April 29, 2019

RE: Preliminary Review of Elcon Recycling Services Facility Land Development and Stormwater Management

Meliora Design has reviewed the plans and documentation related to the Elcon Recycling Services Facility located at 100 Dean Sievers Place in Falls Township, Bucks County, Pennsylvania, including the following documents prepared on behalf of the applicant:

Attachment 1: Panels 53P and 54P from FEMA Flood Insurance Study
Number 42017CV003C, Volume 3 of 6, for Bucks County, PA, Revised
March 16, 2015

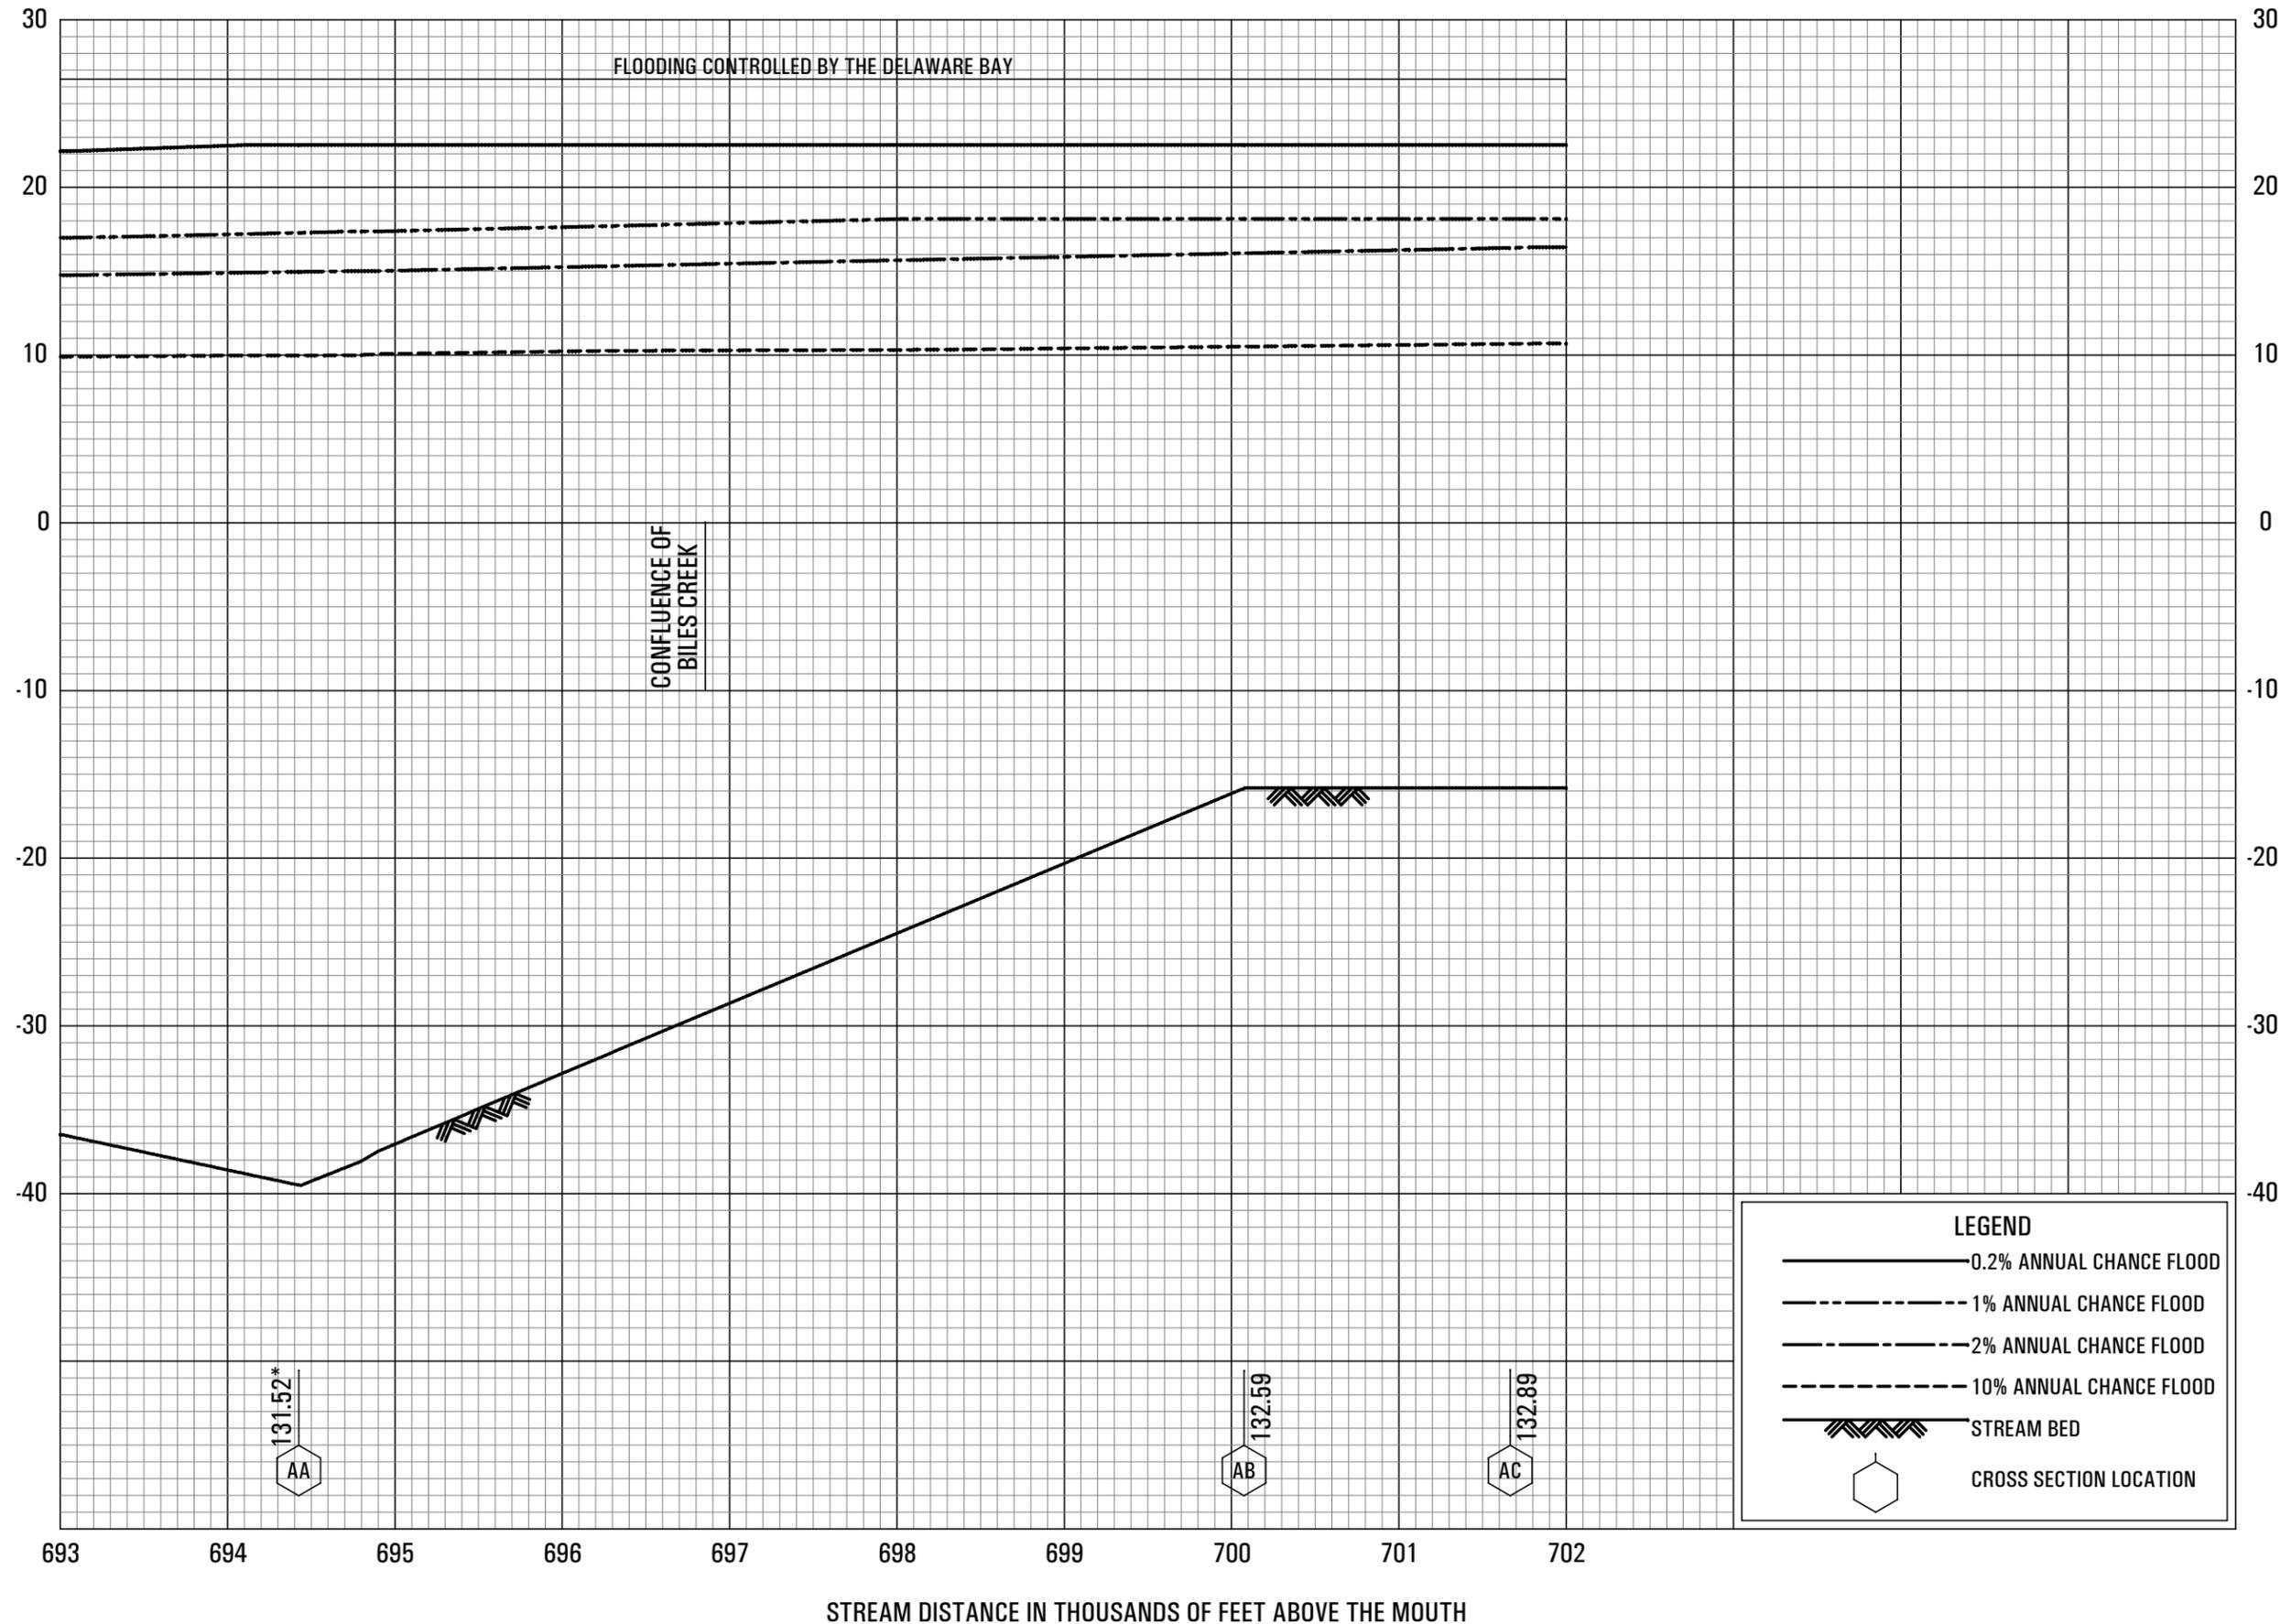
The Flood Insurance Rate Map (FIRM) for Falls Township indicates that the project site is located in the 500-year floodplain. However, the accompanying FEMA Flood Insurance Study Number 42017CV003C Volume 3 of 6 for Bucks County provides projected 100-year flood elevations at various cross-sections along the tidal Delaware River. The indicated 100-year flood elevation for the project site is between elevation 16 feet and 17 feet, NAVD 88. We note that the elevation of the wetlands adjacent to the site is at elevation 10 feet, and nearby Biles Creek connects directly to the Delaware River and would likely reflect the River water surface elevation during an extreme event such as the 100-year flood. We note that in the event of a 100-year flood, both the proposed stormwater basin and the proposed storm sewer system of the facility will be lower than the Delaware flood elevation. It is not clear that the stormwater system will function, and it may surcharge. Some proposed facility units, such as the Biological storage Tank (elevation 19.75) will be only slightly higher than the Delaware River 100-year flood elevation and are also at risk.

As Dr. Richard Nalbandian noted in his memo to DRN, FEMA projected flood elevations are estimates that can vary by several feet vertically. This uncertainty, combined with increased flood levels anticipated from climate change and larger storm surges, means that flood levels will almost certainly be higher in the very near future. The potential for site inundation, and inundation of the proposed stormwater system and basin is of significant concern and could result in the discharge of unknown quantities and types of contaminants to the Delaware River.
